Access Compliance Report

Public Rights-of-Way (Curb Ramps)

Intersection ID: 54301	Main Street: GOLF_LINKS_DR	Cross Street: PROVIDENCE_FARM_LN	Location: SW
ADA ID: E322A9E78809	Ramp Type: Directional1	Initial Pass/Fail: Fail	Overall Compliance: No
		Severity Score: 13.75

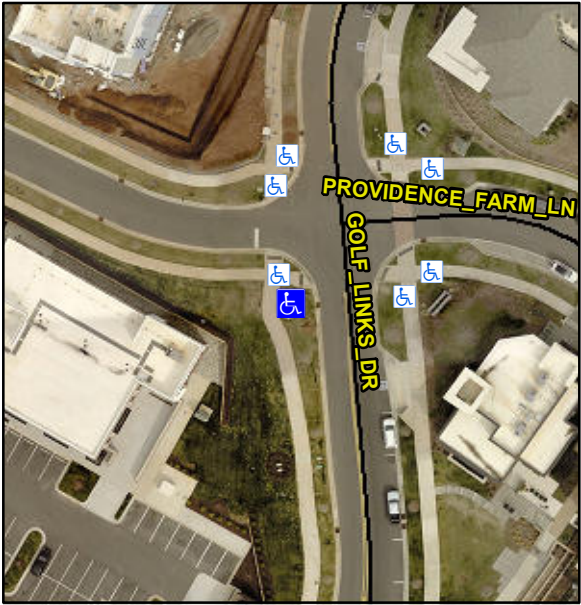
Codes/Mitigation Info/Possible Solution		Field Measurements/Component Compliance			
	Possible Solutions:				
	Remove & Replace Entire Ramp.				
	Surveyor Notes:				
	N/A				
	PROW/ADA:				
	R304.2.2, R304.5.3				
	Street 1 Name	GOLF LINKS DR			
	Stop Condition-Street 1	StopSign			
	Street 2 Name	N/A			
	Stop Condition-Street 2	N/A			
Total Cost:		\$	1600.00		
		Compliance	Description	Data	Compliance Description Data
		N/A	Ramp Length (in)	64.0	N/A Grade Break? N/A
		Yes	Ramp Width (in)	77.0	N/A Grade Break Slope (%) 0.0
		No	Ramp Slope (%)	11.3	N/A Grade Break XSlope (%) 0.0
		No	Ramp XSlope (%)	2.5	
		N/A	Flare Type LT	N/A	N/A Flare Type RT N/A
		N/A	Flare Slope LT (%)	N/A	N/A Flare Slope RT (%) 0.0
		N/A	Flare Traversable LT?	N/A	N/A Flare Traversable RT? N/A
		N/A	Landing Length (in)	0.0	N/A DWS Provided? N/A
		N/A	Landing Width (in)	0.0	N/A DWS Contrast? N/A
		N/A	Landing Slope (%)	0.0	N/A DWS Length (in) N/A
